RE: FW: ECA TR 5 Review

Re: Midwestern Farms, Permit No. M-1993-059, Technical Revision No. 5, CPW Cancellation of Participation in project – Eastern Colorado Aggregates Response, Revision 2.

RECLAMATION PLAN MAP

Permit Name - Midwestern Farms
Reclamation Permit No. M1993-059

Exhibit F

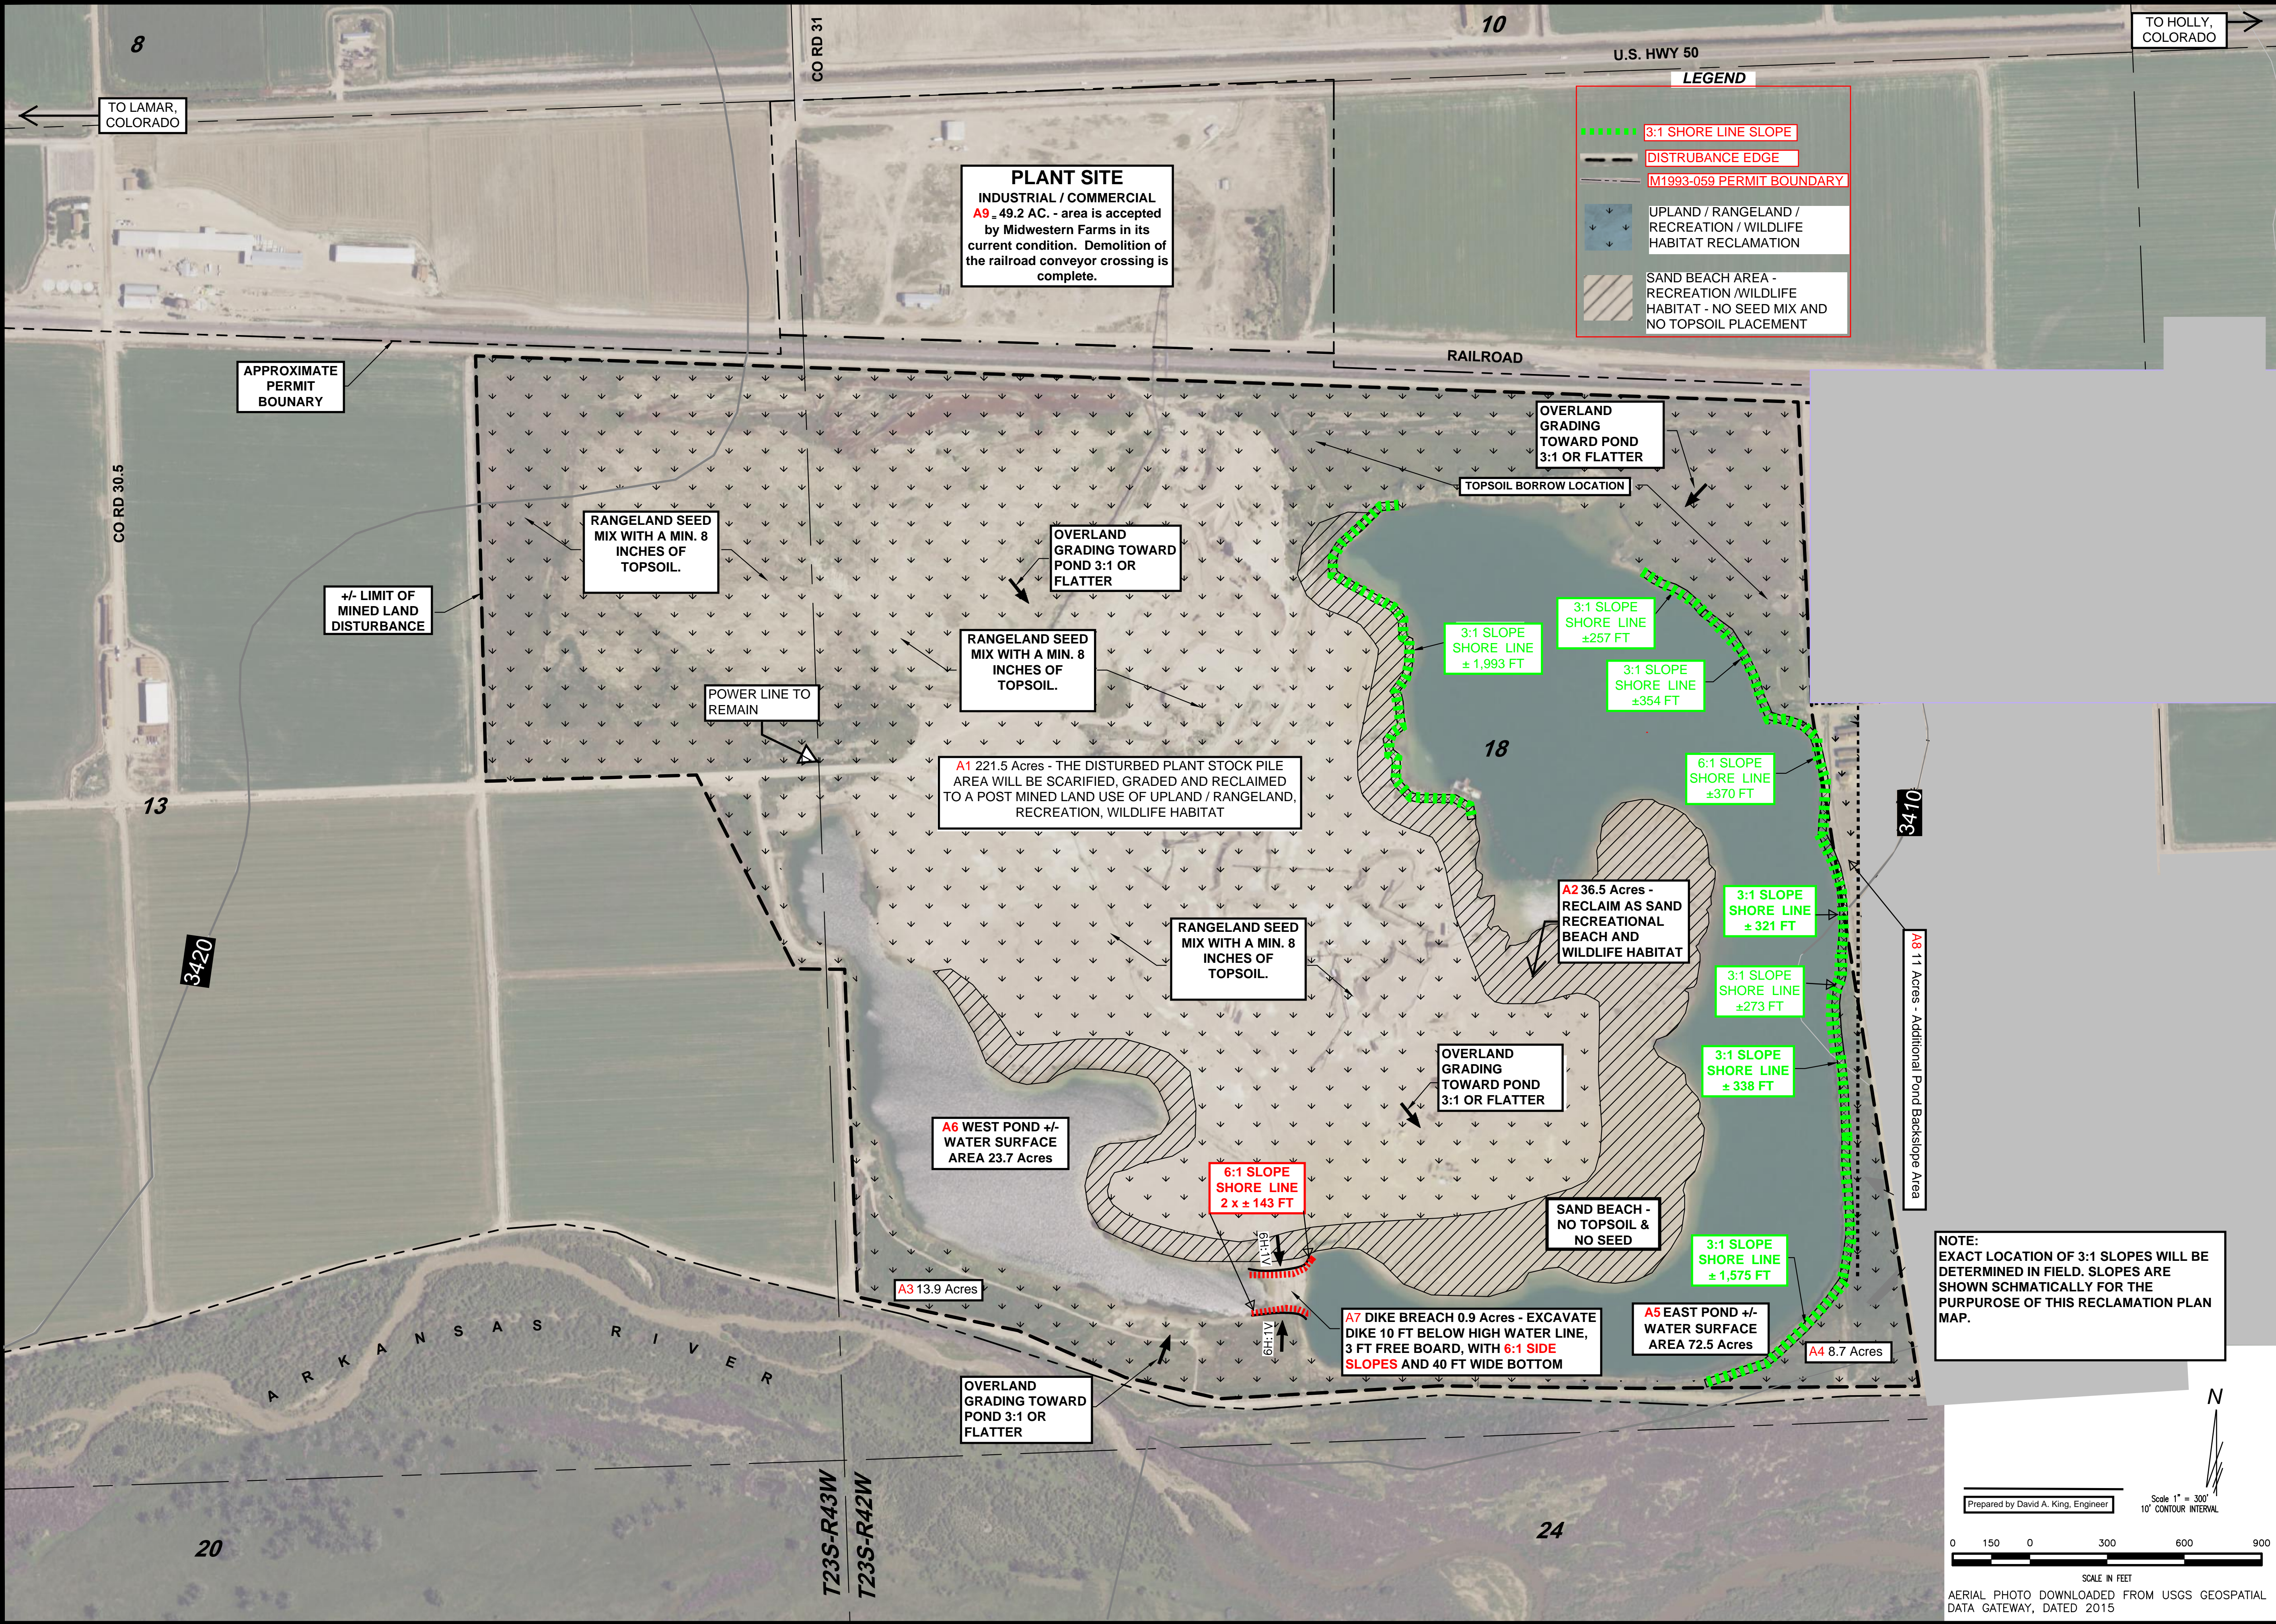
7. **Top Soil** – No additional topsoil borrow is required to cover the site.
 - a. The approximate depth of top soil striping and replacement will be ~~6~~ 8 inches.
 - b. Existing topsoil storage area will have a minimum of ~~6~~ 8 inches topsoil after excavation.
8. **Exhibit F – Reclamation Plan Map** - Please see the revised (2) and legible copy of the Exhibit F – Reclamation Plan Map – which indicates the 8 inches of topsoil.
